DJR OPERATING, LLC
30-045-13282 CENTRAL BISTI UNIT #004

- ☒ P&A ☐ Drilling/Casing Change ☐ Location Change
☐ Recomplete/DHC (For hydraulic fracturing operations review EPA Underground injection control Guidance #84; Submit Gas Capture Plan form prior to spudding or initiating recompletion operations)
☐ Other:

Conditions of Approval:

PLUG AND ABANDONMENT PROCEDURE

CBU #4
Proposed P&A
Bisti Lower Gallup

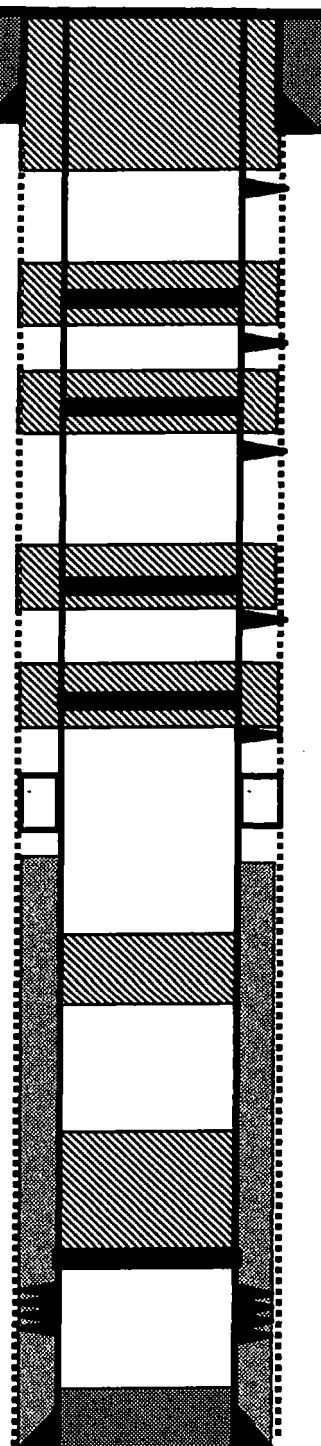
- Notify NMOCD 24hrs prior to beginning operations.
- Extend plug #3 to 2249'-2036' to cover the Mesaverde top.
- Perform a CBL and submit it to the agencies for review prior to cementing.
